SIERRA GEOTECHNICAL SERVICES INC.

Subject: **RESPONSE TO PEER REVIEW**
Phase 2 of Tentative Tract 37-46
White Mountain Estates Subdivision
Chalfant Valley, Mono County, California

Reference: Review Of Earthquake Fault Zone Hazard Evaluation Reports
Tract 37-16 And Phase 2 of Tentative Tract Map No. 37-46
White Mountain Estates Subdivision
Chalfant Valley, Mono County, California
Prepared by AMEC Earth & Environmental dated January 12, 2006

PROJECT: GEOLOGIC LOG OF DEEPEND TRENCH T-5 PHASE 2 OF WHITE MOUNTAIN ESTATES SUBDIVISION				
HORIZ. SCALE: 1"=5'	VERT. SCALE: 1"=5'	DATE: 3/29/2006		
DRAWING: 3.30559_DEEP_TRENCHES.DWG	LOGGED BY: HDD/RWS		DRAFTED BY: HDD/RWS	
	JOB NO.: 3.30559		TITLE: SHEET 4 OF 7

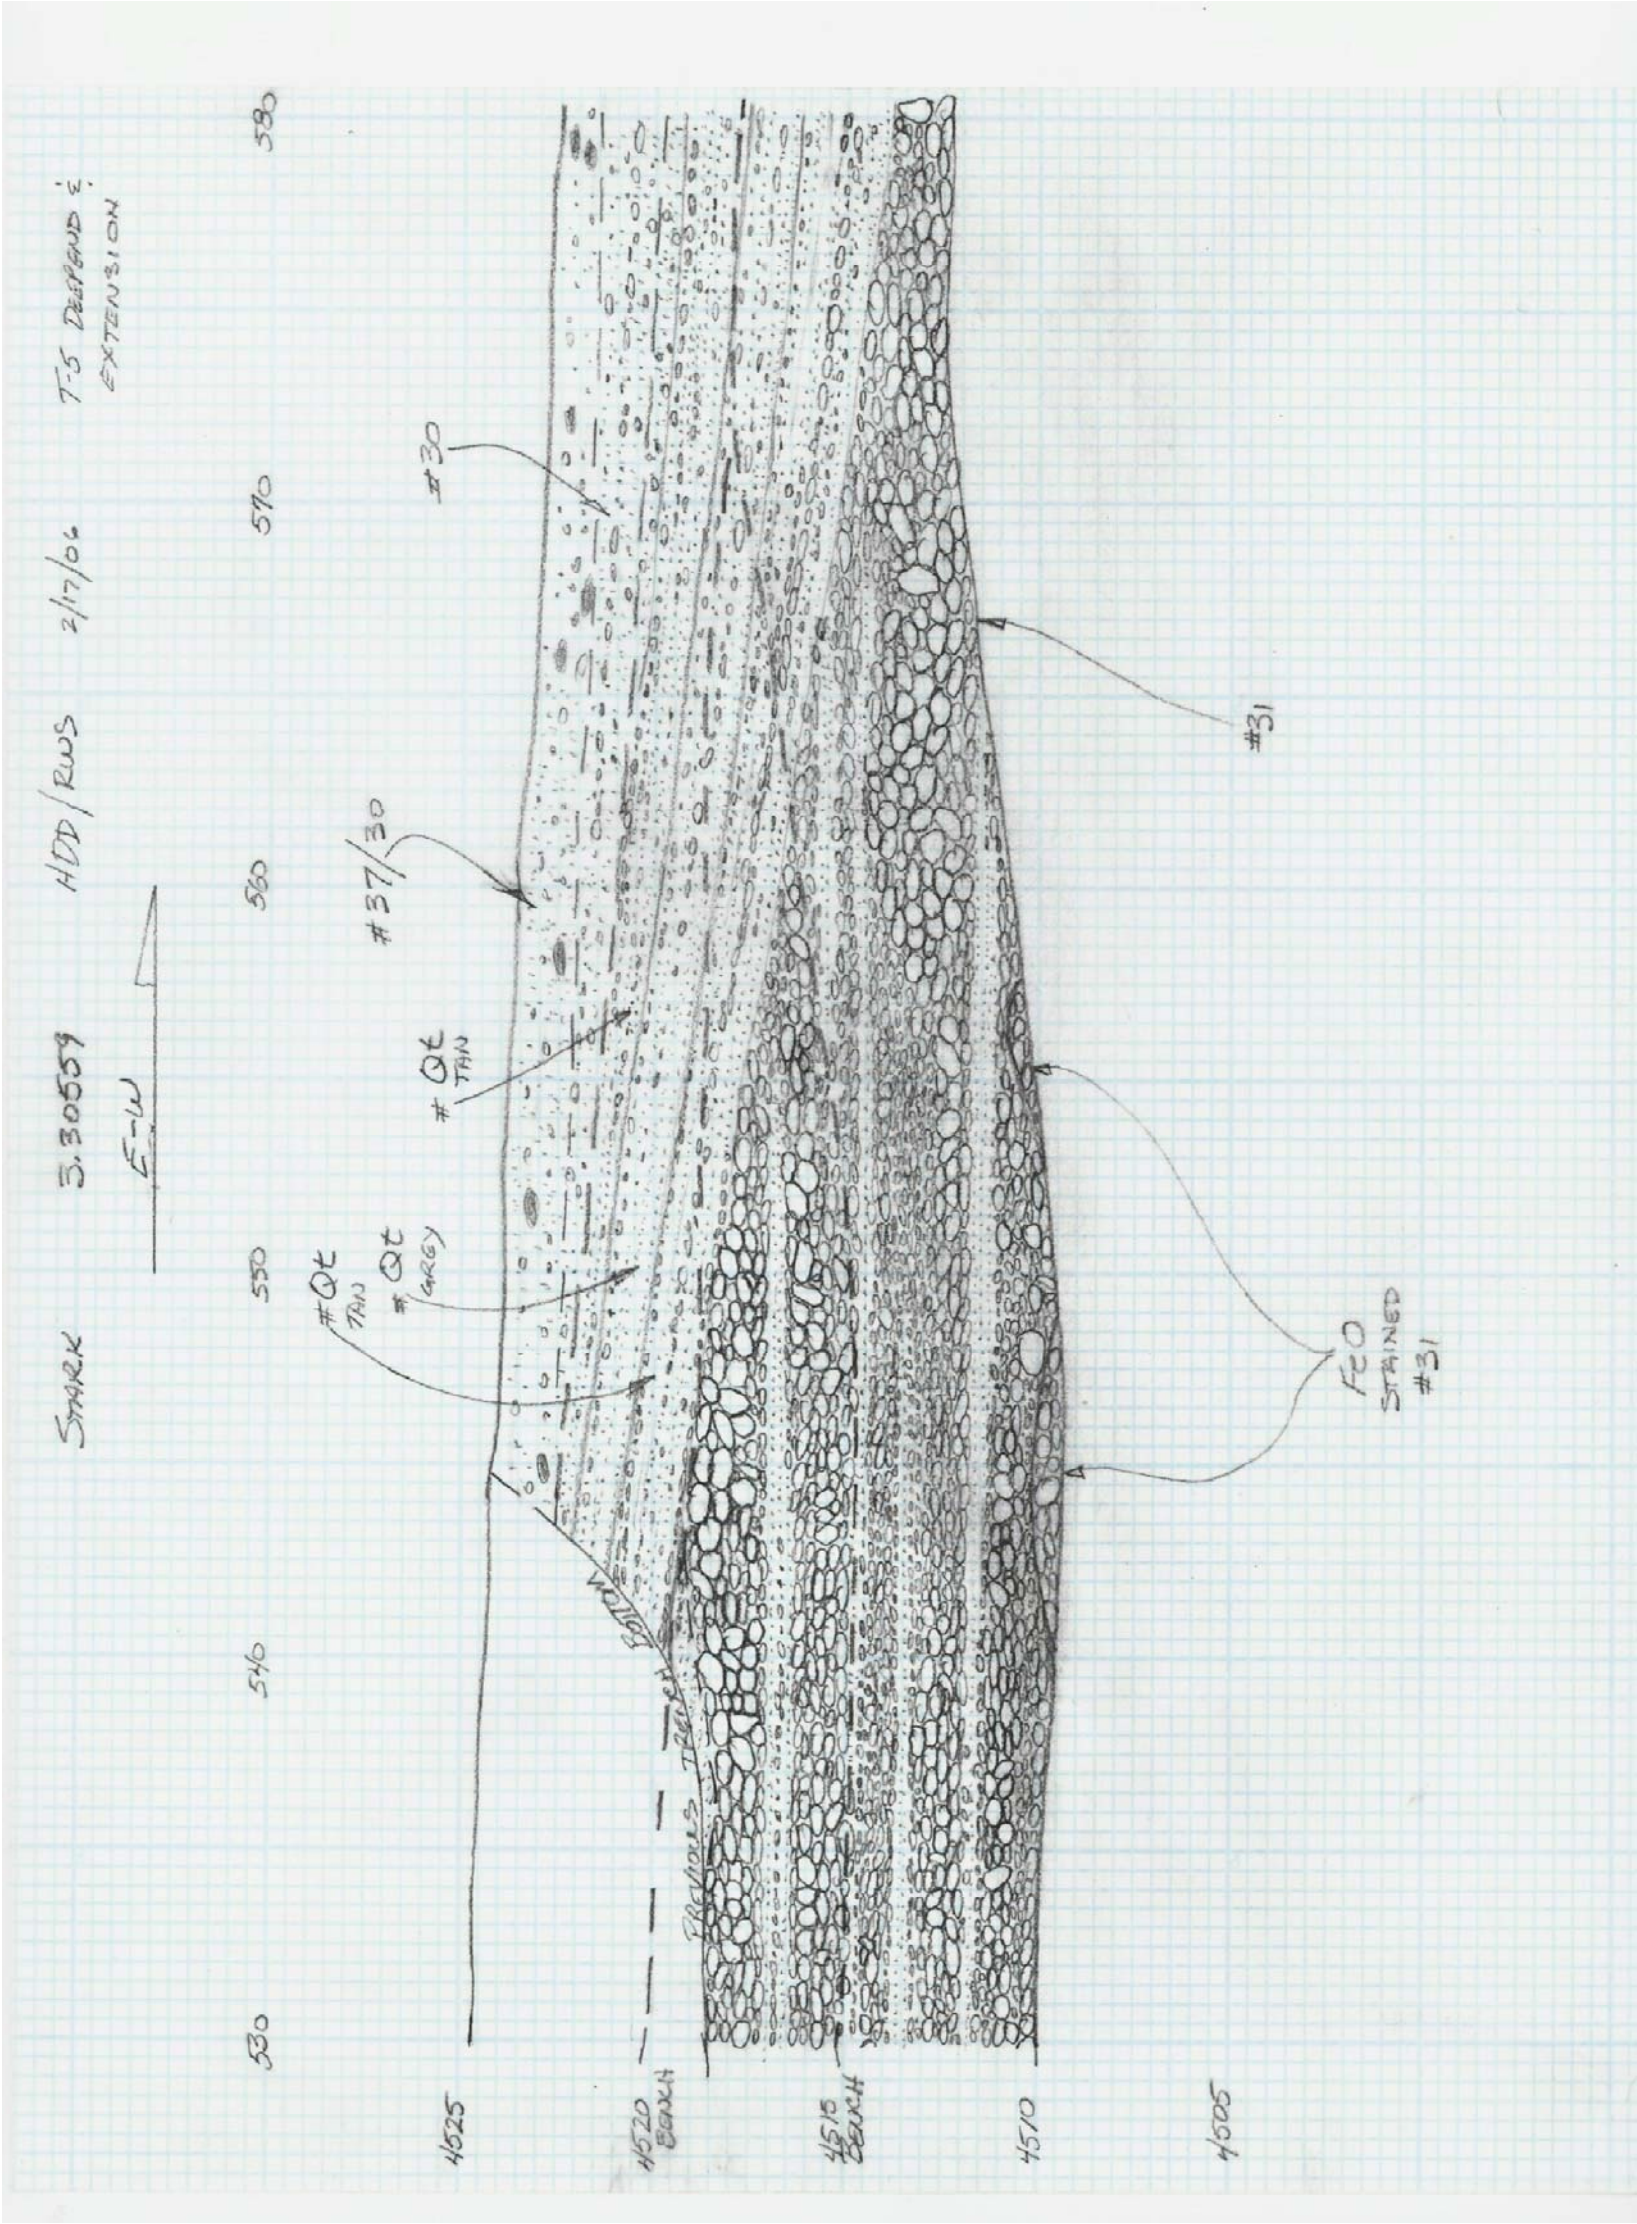
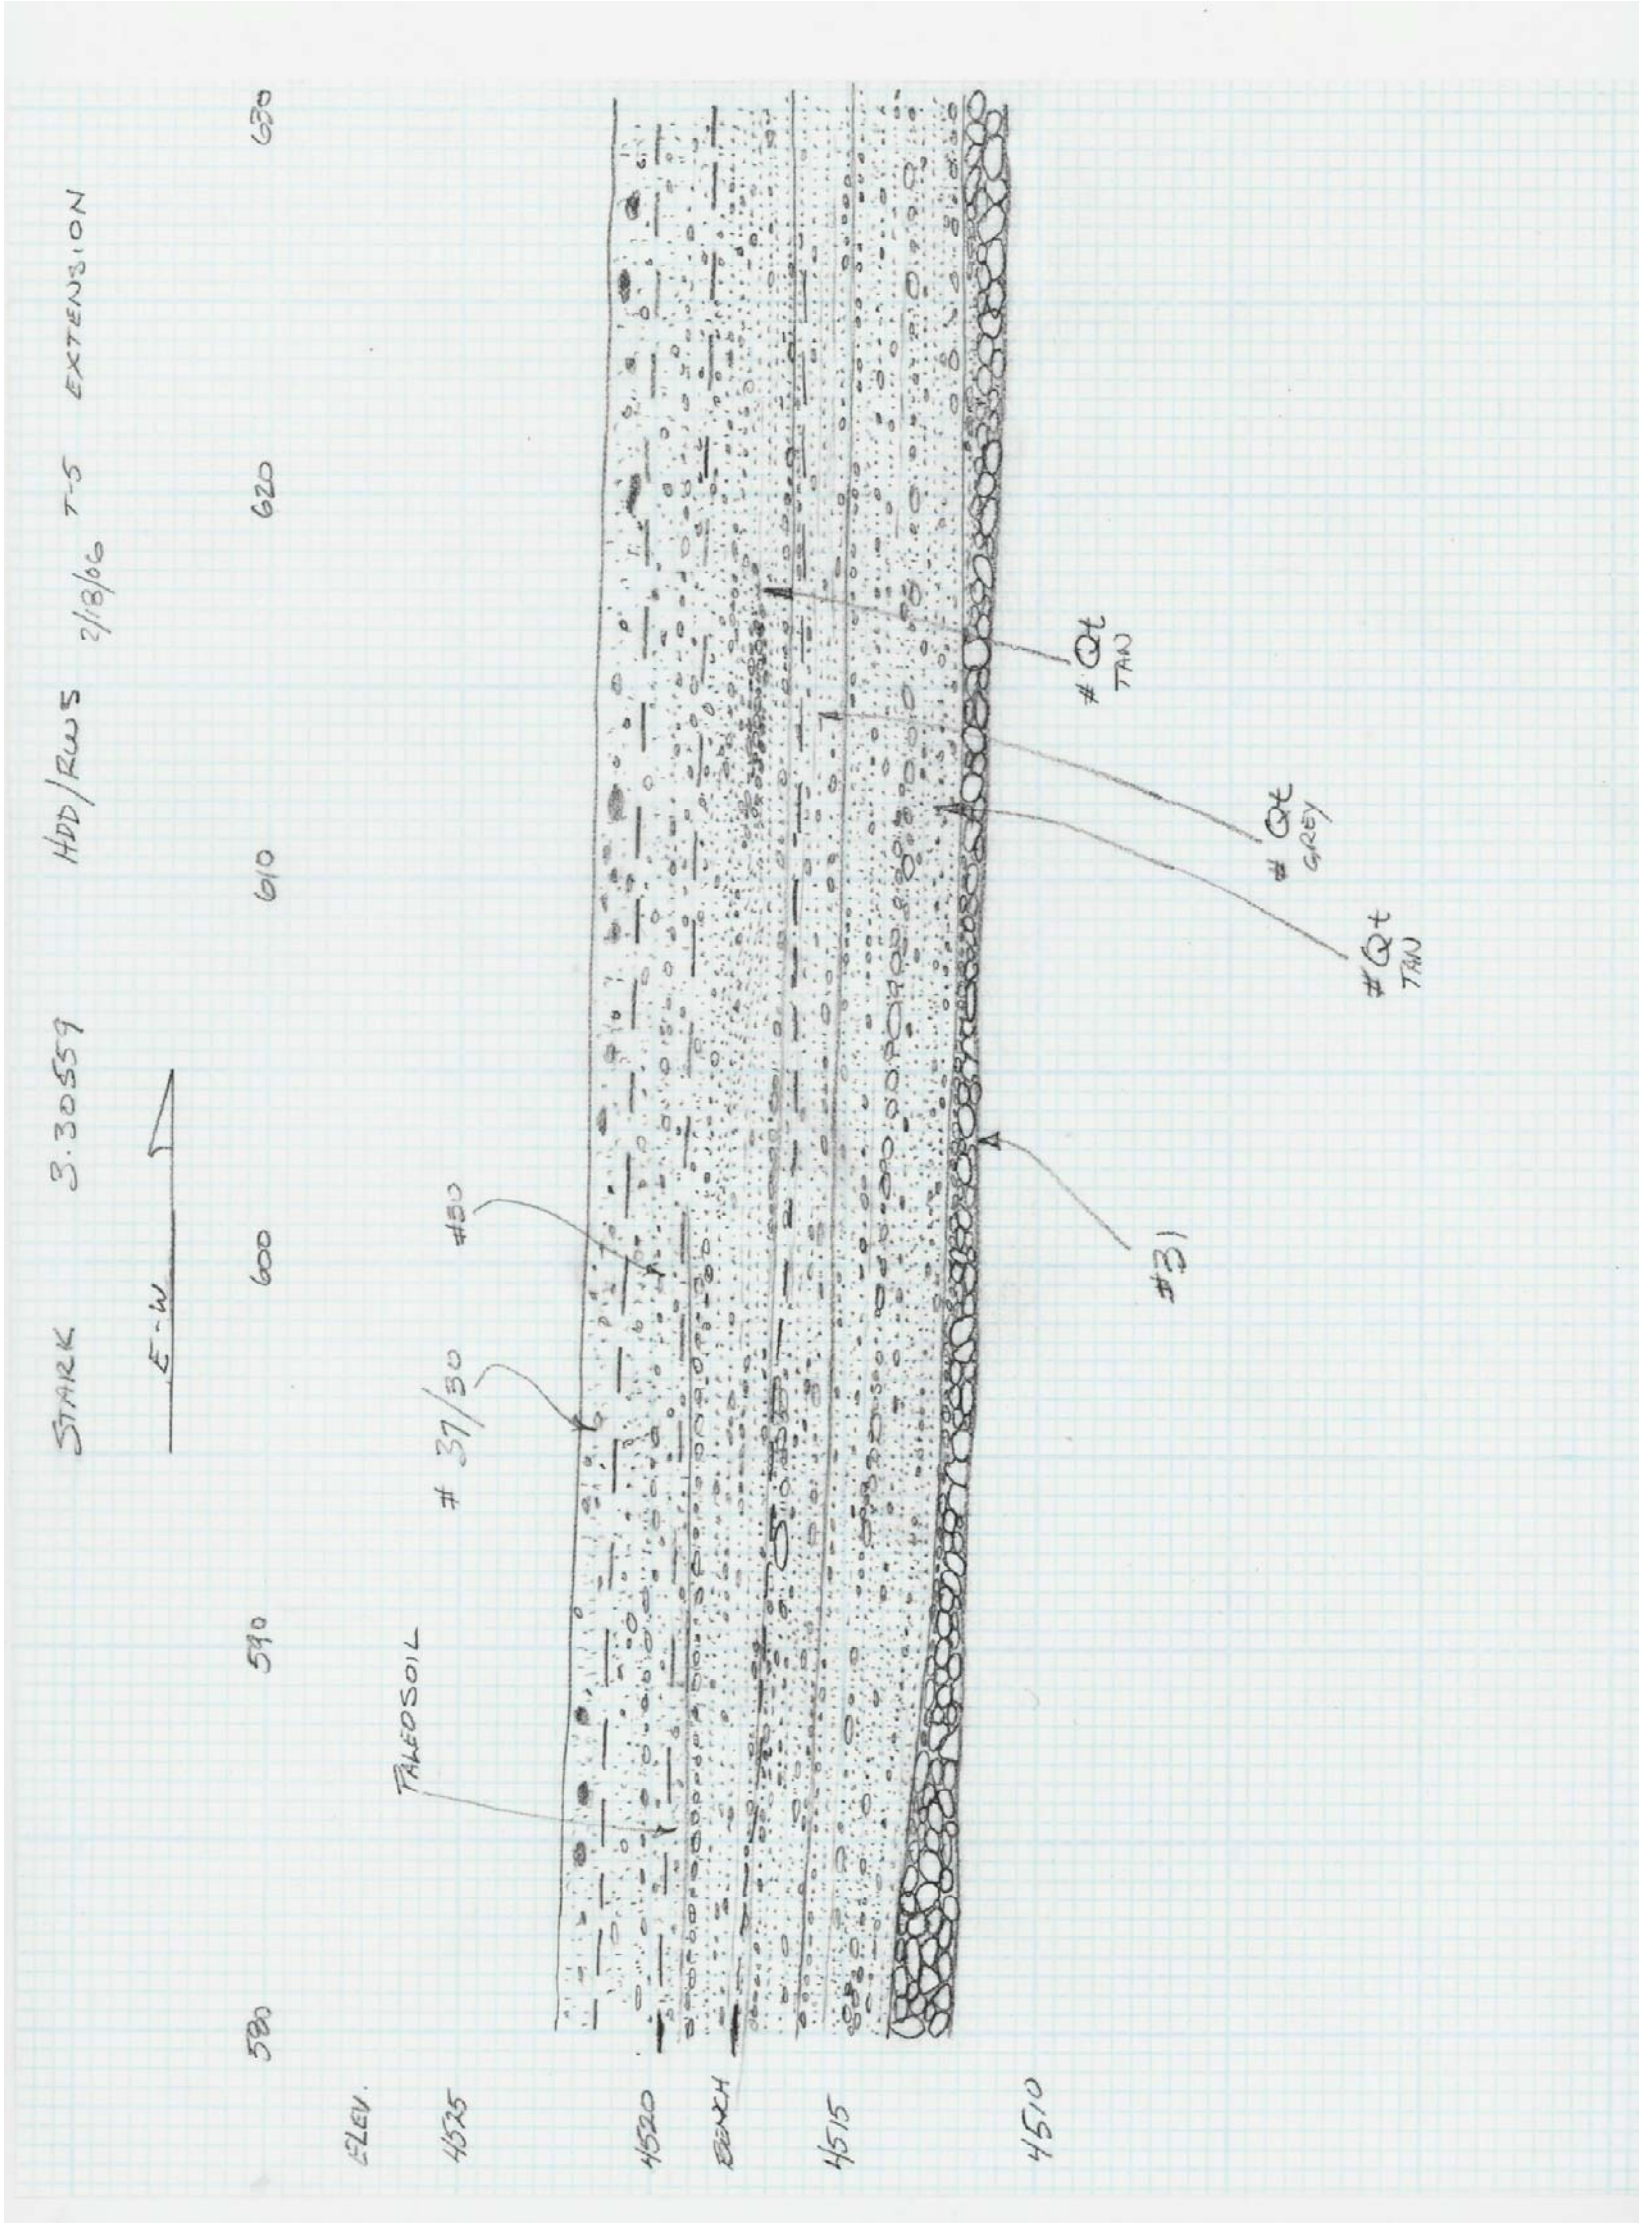
The designated habitable areas within Lot 45 are based on the fault related features and their structural orientations as observed and subsequently depicted in the logs of Trenches T-5 and T-6. The geomorphic features mapped within Lot 45 have been designated as Qfy (2), Qfi (3/4) and Qfo (6) having respective ages varying from Holocene to Middle-Early Pleistocene as previously determined by Bruce Schell. The alluvial sediments exposed in the fault Trench T-5 and T-6 are described by SGSI as being recent to late Pleistocene in age. The designated habitable areas within Lot 45 are depicted as two triangular shaped areas that are approximately 140 [feet] wide at their widest point. The easterly most area is situated on uplifted and eroded terrain associated with the Qfo (6) alluvial terrace surface. The proposed habitable area to the west is situated on recent alluvial deposits principally within an active drainage course.

The easterly 340 [feet] of Trench T-5 is situated within terrain that has been mapped as Qfo (6). A significant portion of these alluvial deposits appear to have been cut by active faults. The only portion that appears to have been unaffected is the roughly 35 [foot] wide section between Stations 2+88 and 3+23 that is inclined at a gradient of approximately 29 percent. This area may (sic) not be large enough to be considered buildable particularly when considering its narrow shape and the steepness of the existing ground surface.

The westerly portion of Trench T-5 from Station 3+40 to 5+26 is largely underlain by recent alluvial deposits. The contact at the base of the Holocene alluvial sediments has not been exposed over most of this portion of Trench T-5 and as such a definitive statement regarding the active faulting cannot be made by the project consultant. Based on these conditions it is recommended that the proposed habitable [area] associated with the westerly portion of Trench T-5 not be accepted without deepening of the trench to expose the full section of Holocene alluvial fan deposits, from the contact with the underlying Pleistocene alluvium to the ground surface, that are unaffected by fault features. The project consultant should also consider the buildability of this area considering the potential for flood related issues as this area is largely situated in an active drainage course.

Response: In conformance with the recommendation provided in the comment above, Trench T-5 was re-trenched to expose the full section of the Holocene alluvial fan from the ground surface down to its contact with the underlying older Pleistocene alluvium. Deepened Trench T-5 was also extended west for an additional 155 feet to Station 7+00. Based upon our observations and logging of the deepened exposure, active faulting was not observed in the older deposits between Station 3+40 through 5+26. This find is not consistent with the faults found in Trench T-6 to the south. An effort was made to crosscut the faults projecting northward from Trench T-6 in order to account for the lack of faulting observed in deepened Trench T-5, but this could not be accomplished. Instead, both the geologic log of Trench T-6 and the geomorphic expression of the topography surrounding Trench T-6 were re-interpreted to be a landslide, which accounts for the lack of faulting in deepened Trench T-5. Landslide features are observed in Trench T-6, and they include a buried head scarp at Station 2+90, a backfilled graben between Stations 2+90 and 3+85, back-rotated landslide blocks between Stations 3+85 and 5+10, and basal slide planes near the landslide toe between Stations 5+10 and 5+38. Geomorphic landslide

features are also observed in the topography that surround Trench T-6, and they include a steepened slope at the landslide head, two re-entrant gullies ascending up to the landslide head from the drainage on the north and from the drainage on the south, and “over-steepened” slopes on both hills that ascend from where these drainages converge, which is the same location where the landslide came to rest. The landslide has been somewhat modified and “melted” by cumulative erosion over time, but the geomorphic features are still substantially preserved.

Active faulting was observed at the westernmost extent of deepened Trench T-5 from Station 6+80 to 7+00. This observation is a better fit for Significant Fault No. 3, which projects north from the westernmost extent of Trench T-6. It is interpreted that this east-dipping fault provided the mechanism by which movement occurred along the toe for this landslide. Therefore, based on the new data observed in deepened Trench T-5 our new interpretation for the landslide in Trench T-6, and the potential for flood related hazards from the drainage, the proposed habitable areas on Lot 45 have been revised, and they are delineated on the Revised Geologic Map.
